AERONAUTICAL CHARTING FORUM
Instrument Procedures Group
Meeting 04-01 – April 28-29, 2004
History Record

FAA Control # 04-01-253

Subject: LNAV/VNAV Landing Minimums

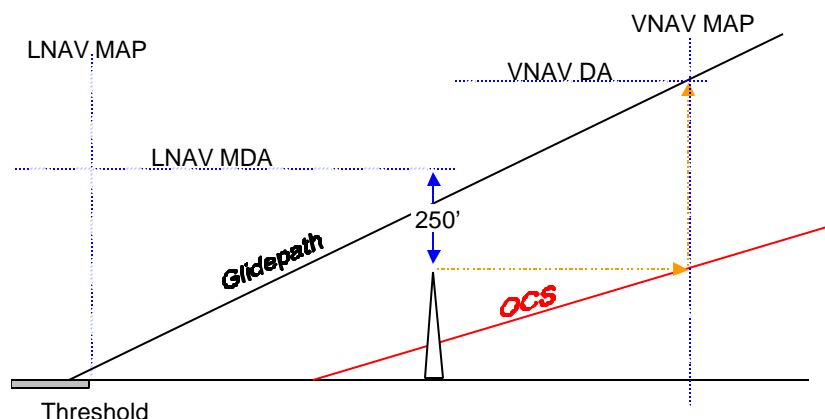
Recognizing the CFIT accident rate is 7 times greater for nonprecision (2-D) approach procedures than for vertically guided (3-D) approach procedures, the FAA and industry agreed to promote flying 3-D procedures by providing LNAV/VNAV approach procedures to all 14 CFR Part 139 runways. A 3-D approach procedure enhances safety by placing the aircraft in a position and on a trajectory for landing at DA (MAP) while a 2-D procedure allows the aircraft to proceed at MDA to the runway threshold (MAP) in a more difficult position to complete a landing. The provision of 3-D procedures is an effort to lower the accident rate, not necessarily to achieve lower minimums.

It is very possible for the visibility minimums or DA value of a 3-D approach to be greater than a 2-D approach. 2-D approaches require an MDA value that is 250' (ROC value) above the highest obstacle. Additionally, the 2-D approach procedure MAP is usually at the runway threshold; therefore, the distance from MAP to threshold is zero. On a 3-D approach procedure, the DA (MAP) occurs at a point on the glidepath, which is a distance from the threshold determined by where it occurs on the glide path. The no-light visibility value (based on MAP to threshold distance) of a given 3-D approach may be greater than the 2-D procedure.
